RE: Department of Energy Oversight Bureau (DOE OB) Inspection Observations and Recommendations concerning NPDES outfalls scheduled for deletion through the Waste Stream Characterization Program at Los Alamos National Laboratory (LANL).

DOE OB Inspection Observations and Recommendations

Fig. 3-1. The five major locations at TA-33.

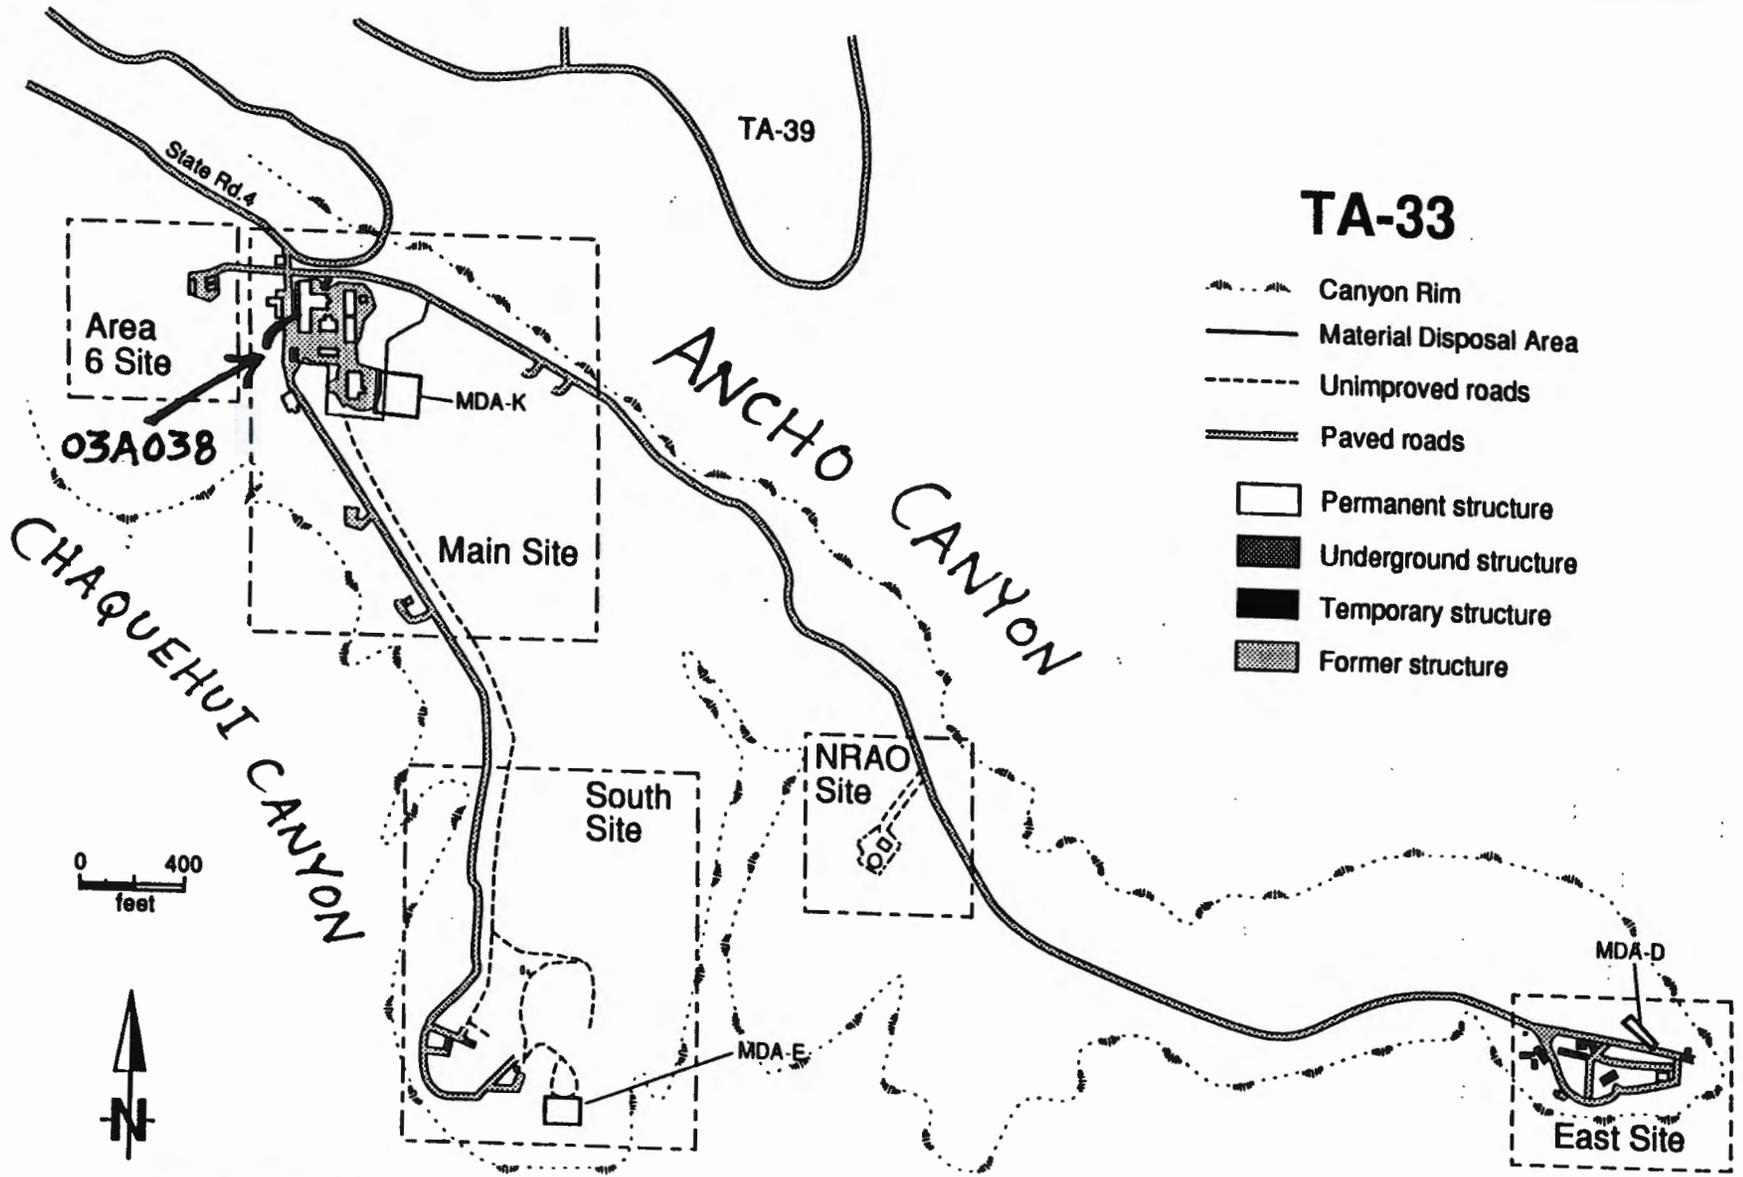
LOCATION: Building TA-33-114 (see TA-33 attachment)

OBSERVATIONS: All work needed to close this outfall from the interior of building was performed. This outfall will continue to receive storm-water from exterior roof and storm drains. These exterior sources are not known to be SWMUs or come in contact with any SWMUs. This outfall exits to a pipe that discharges to a tributary of Chaquehui Canyon. This outfall does not discharge to any known SWMUs immediately below or down-gradient of the pipe. It has not been officially determined whether future storm-water discharges from this outfall will be addressed under a general storm-water NPDES permit.

RECOMMENDATION: The DOE OB recommends that this outfall be taken off the industrial NPDES permit.

Figure 3-3. Locations of structures and SWMUs at TA-35 (LANL 1986, 04-0249).

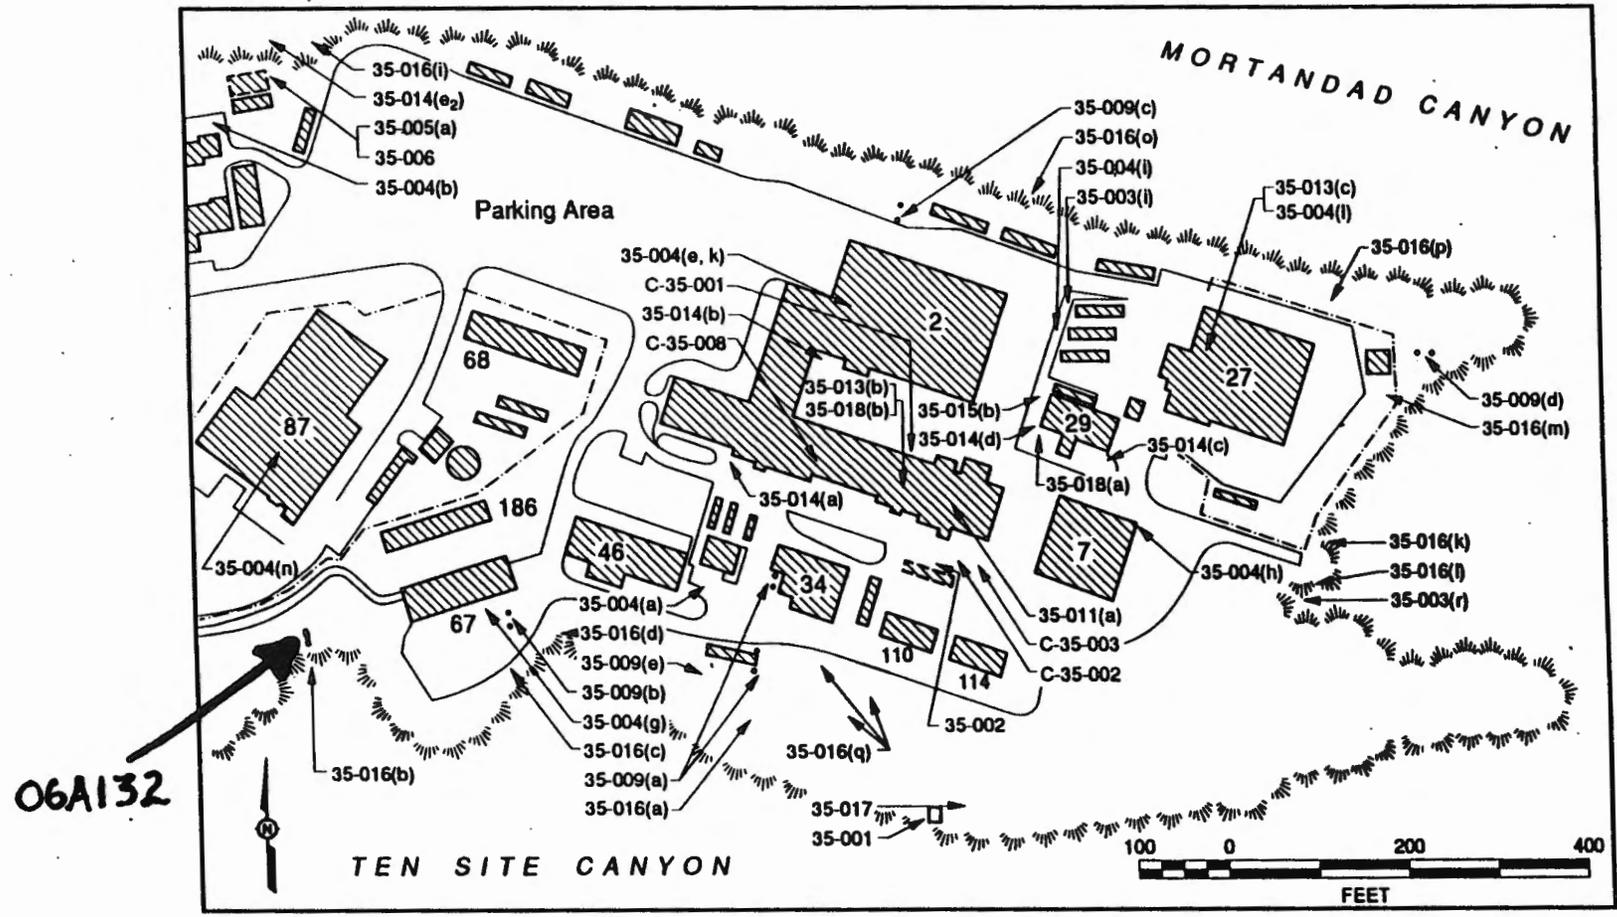
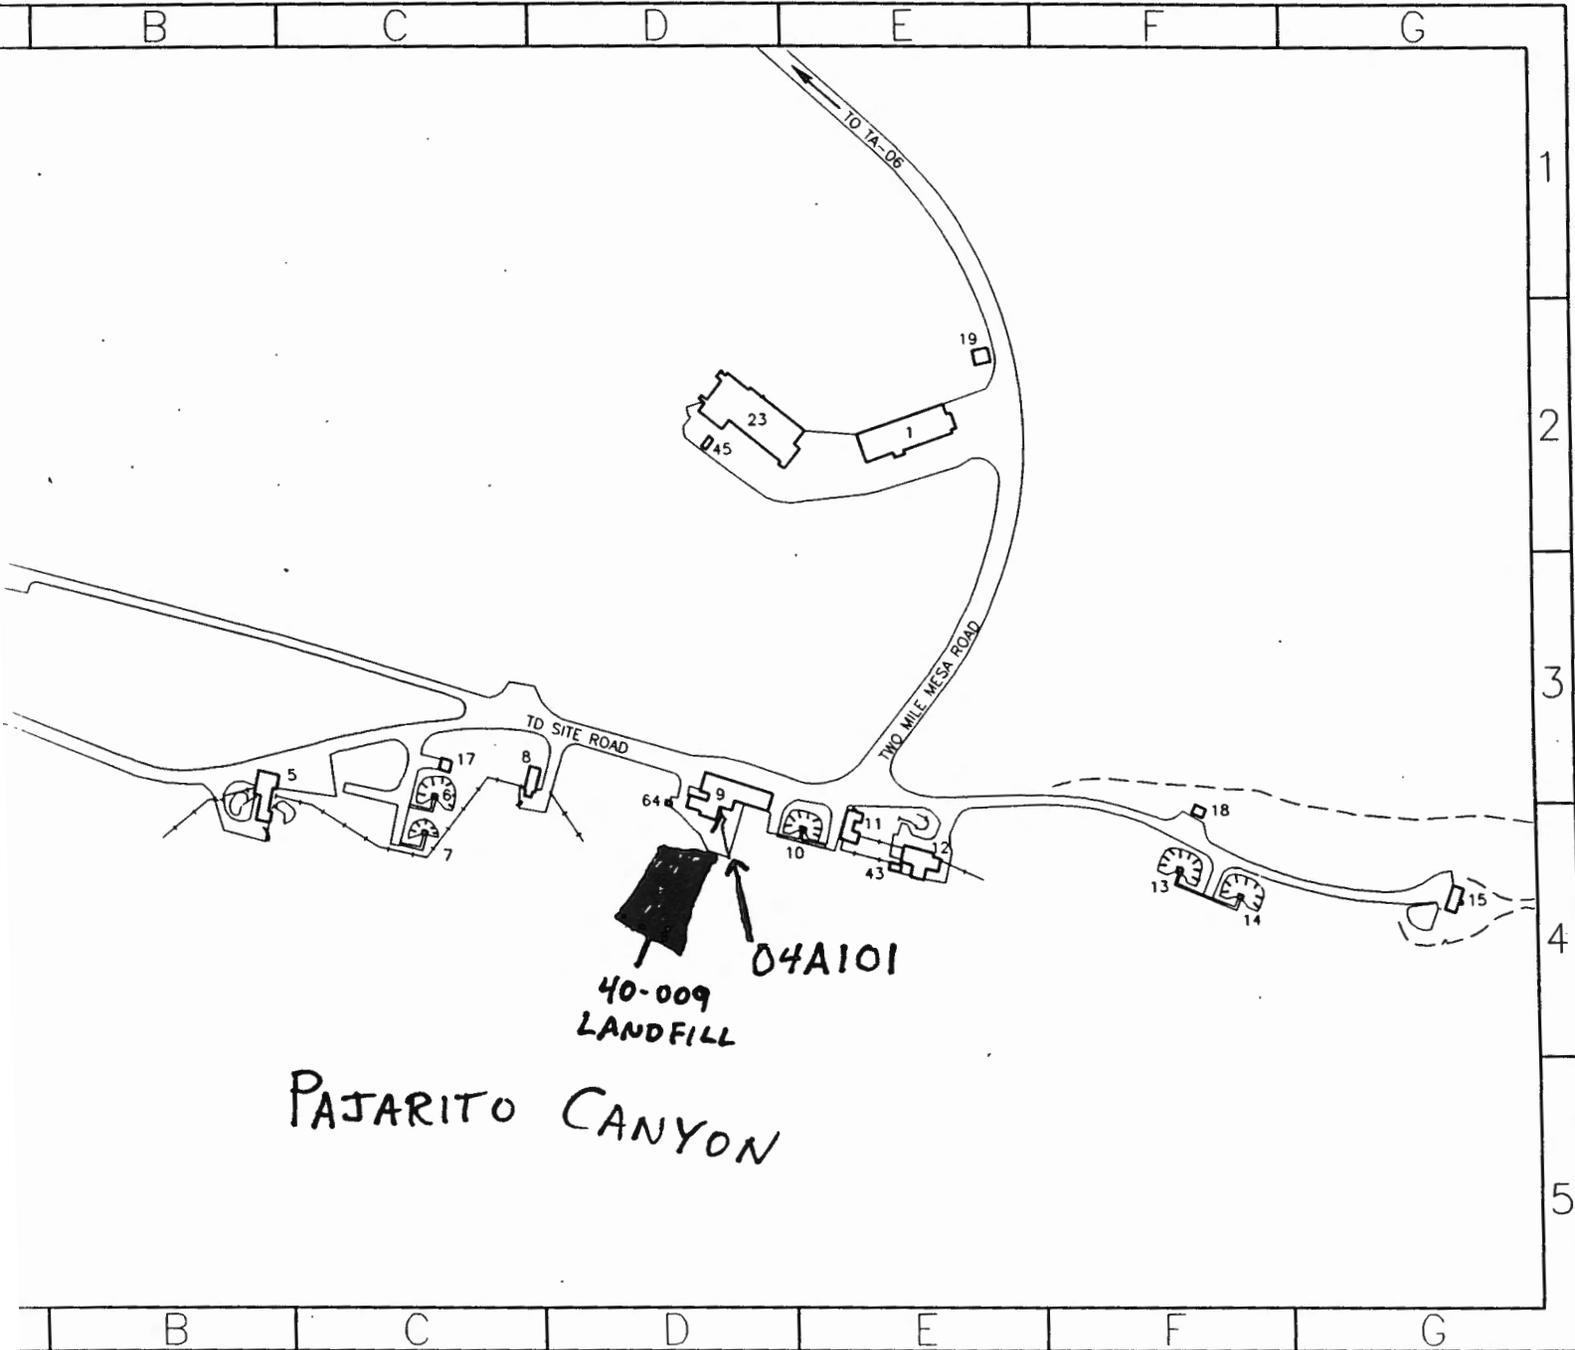
LOCATION: Building TA-35-87 (see TA-35 attachment)

OBSERVATIONS: All work needed to close this outfall from the interior of building was performed. This outfall exits to a 6 inch white PVC pipe that discharges to Tensite Canyon south of Building TA-35-87. This outfall is still listed as SWMU 35-016(b) which formerly discharged photographic processing effluents. This outfall will continue to receive storm-water from exterior roof

drains. These exterior sources are not known to be SWMUs or come in contact with any SWMUs. Additional SWMUs are known to exist in Tensite Canyon down-gradient of the pipe discharge area. It has not been officially determined whether future storm-water discharges from this outfall will be addressed under a general storm-water NPDES permit.

RECOMMENDATION: The DOE OB recommends that this outfall be taken off the NPDES industrial permit. Because this outfall is a SWMU, the DOE OB additionally recommends that the pipe and the area immediately below the outfall be investigated for contamination before storm-water is freely allowed to be discharged. If such investigation results show that soils or sediments are impacted, we recommend that this outfall not be used for storm-water discharges because this would cause migration of contaminants down-gradient. In addition, we also recommend the implementation of best management practices such as run-on controls in order to divert any storm-water away from SWMUs directly below and down-gradient of the outfall pipe.
